# PLANNING COMMISSION MEETING

LOCATION: TOWNSHIP ANNEX, 7527 HIGHLAND ROAD, WHITE LAKE, MICHIGAN, 48383 (FORMER WHITE LAKE LIBRARY)
THURSDAY, JUNE 16, 2022 – 7:00 PM

- 1. CALL TO ORDER
- 2. ROLL CALL
- 3. PLEDGE OF ALLEGIANCE
- 4. APPROVAL OF AGENDA
- 5. APPROVAL OF MINUTES
  - A. Minutes of May 19, 2022
- 6. CALL TO THE PUBLIC (FOR ITEMS NOT ON THE AGENDA)
- 7. PUBLIC HEARING
  - A. Elizabeth Lake Retail

White Lake Plaza- Preliminary Site Plan Review - 8th Review RE:

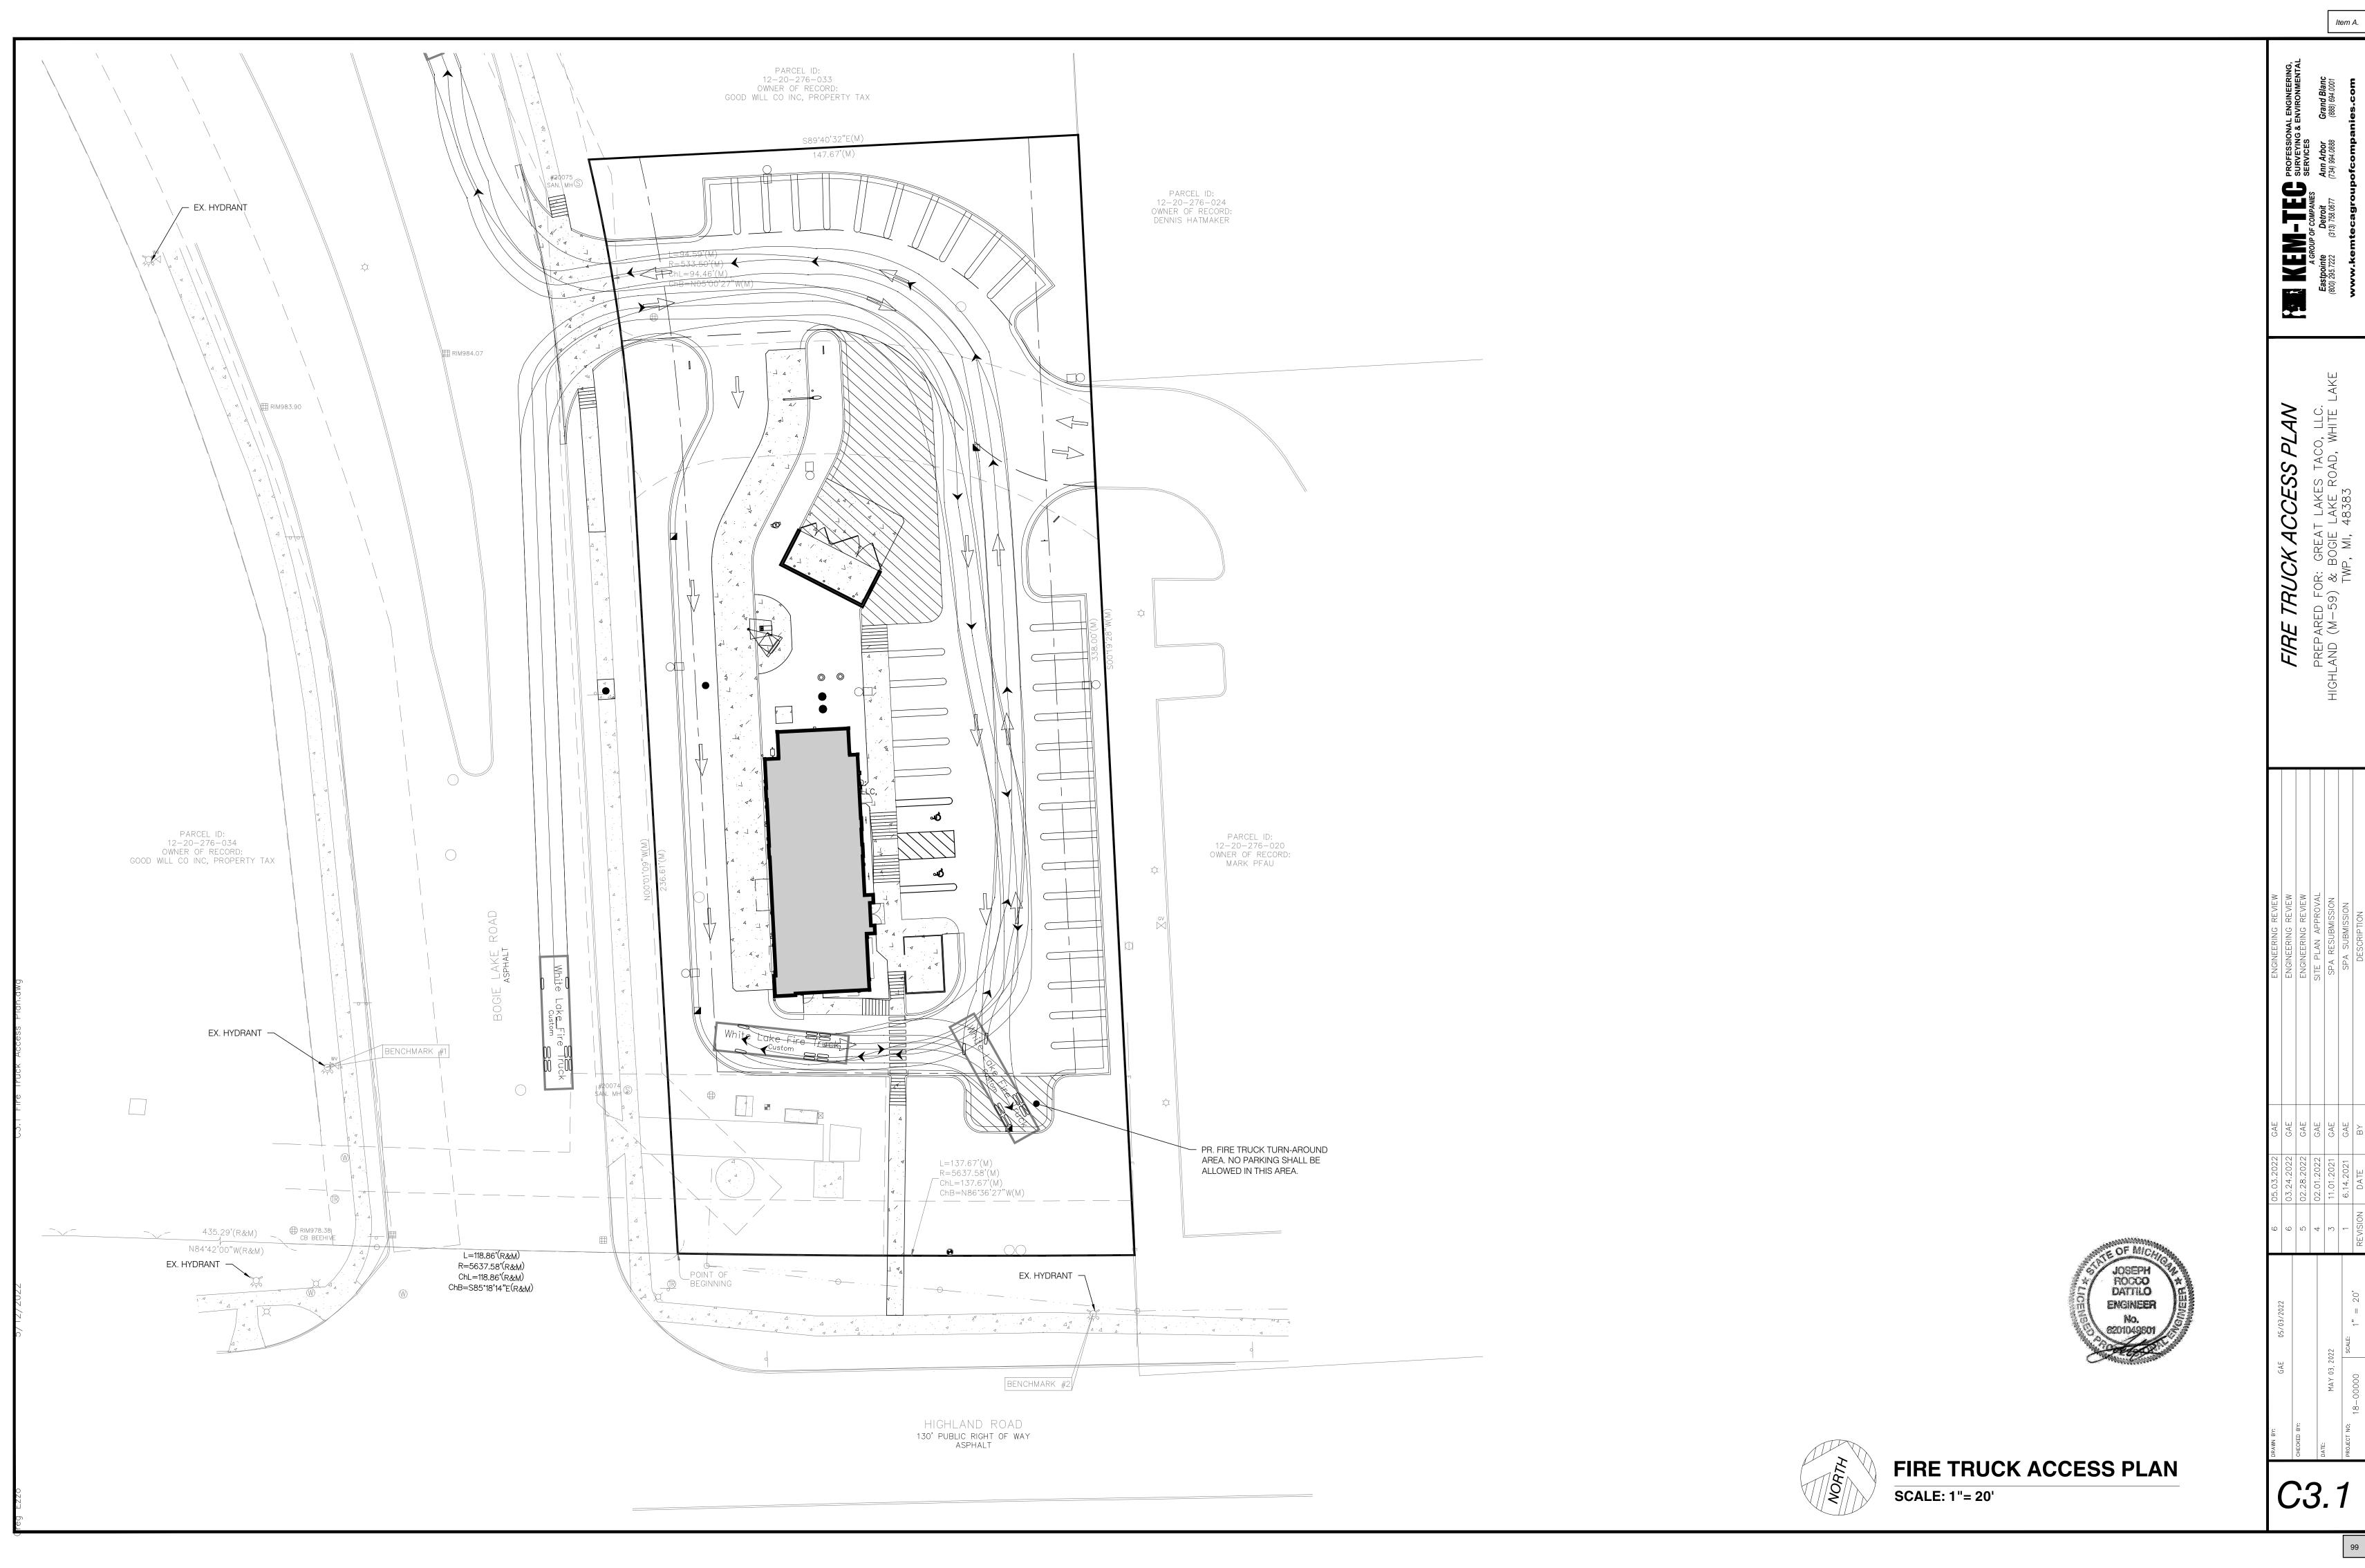
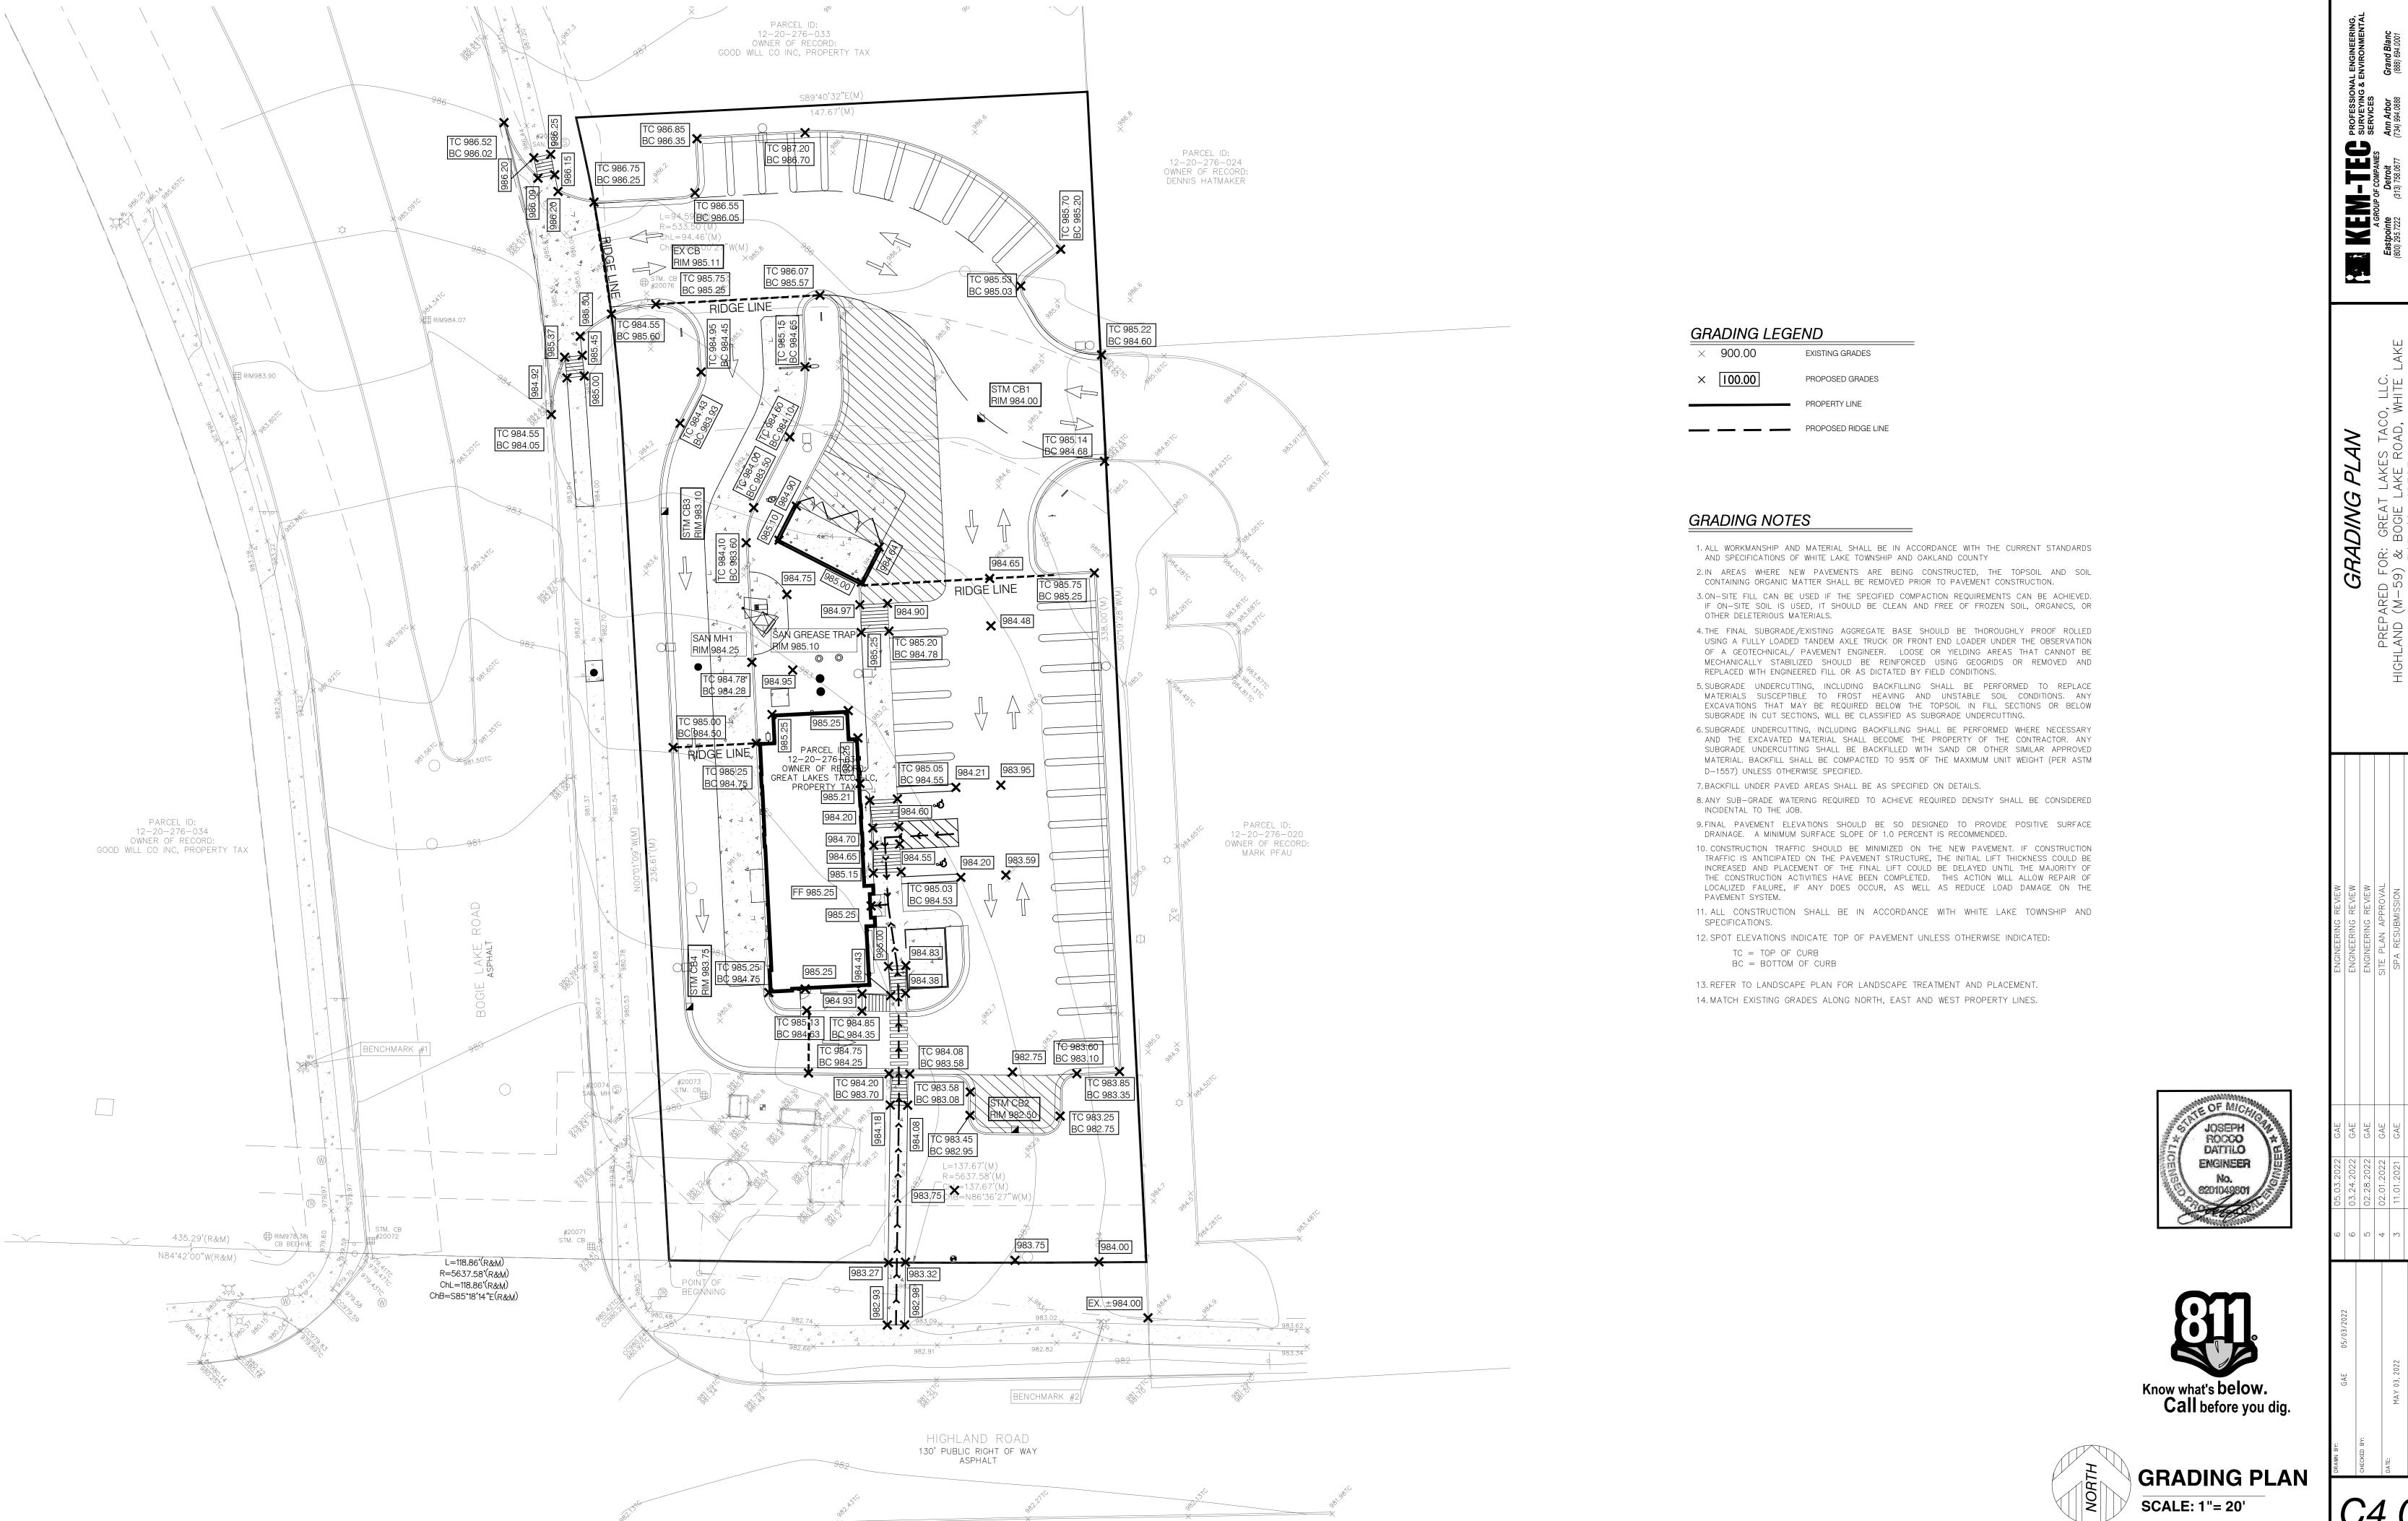
- 1. Revise note on Sheet 3.0 (Site Layout and Paving Plan) from "<u>Pr</u>. Concrete sidewalk to remain and be repaired in kind" to" <u>Ex</u>. Sidewalk...." Comment addressed.
- 2. Kem-Tec plan shows parking stall striping per the zoning ordinance; the architectural site plans do not. Comment addressed. Architectural sheets have now been updated.

1. Remove reference to Plymouth Township under 'Utility Notes' Item 10 on Sheet C5.0. Comment addressed. Note has been revised.

- 2. Show easements for proposed storm sewer on Sheet C5.0. Comment outstanding. The design engineer response letter refers this item to the Meijer Storm Water Agreement of which we did not receive. In addition, the easements for the proposed Taco Bell storm sewer shall be shown on the Utility Plan (Sheet C5.0). Comment partially addressed. The easements for the proposed storm sewer will need to be shown on the plan. Although the design engineer has stated in their response letter that Meijer will not require any additional storm maintenance easements within the Taco Bell Development site, storm easements are required for the proposed storm sewer on the Taco Bell site per White Lake Township requirements. Comment addressed. 10' wide easements are now shown on utility plan.

**ENDEAVOR 2.0 PHOTOMETRIC** SITE PLAN

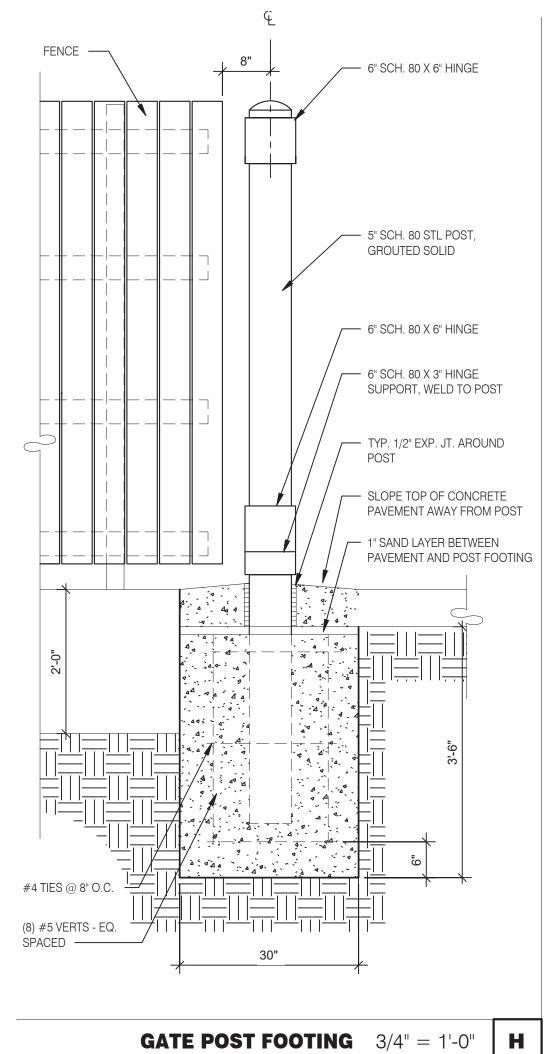
- The Westgate floodlights (Fixture H1) shall not be installed and shall be removed from the photometric plan (Sheet A0.7).
- For the LSI Industries, Inc. luminaries, the lumens listed in the Fixture Schedule on the photometric plan (Sheet A0.7) do not match the lumens from the lighting fixture specification sheets. Revise the Fixture Schedule to be consistent with the catalog details.

- Separate catalog details shall be provided for the Lithonia Lighting Fixture E2E.
- The light pole detail on Sheet A0.7 shall be revised. As stated in previous correspondence, the light pole detail shall indicate the total height including the base, pole, and light fixture (measured to the top of the fixture or pole, whichever is greater). In the Applicant's response to the last FSP review, it was stated the pole height was indicated on the detail. Contrary to said statement, the pole height was not indicated on the detail. Furthermore, the total height indicated (16 feet) is incorrect. The Fixture Schedule on the photometric plan and a note added to the aluminum square pole specification sheet by the Applicant indicated the poles would be 13.5 feet in height. On the Pole Selection Chart on the specification sheet, there is not an option for a 13.5-foot-tall pole. Additionally, the fixtures on the pole-mounted luminaires would be 7.6-inches in height from the point where the fixture meets the pole to the sky-side of the fixture.
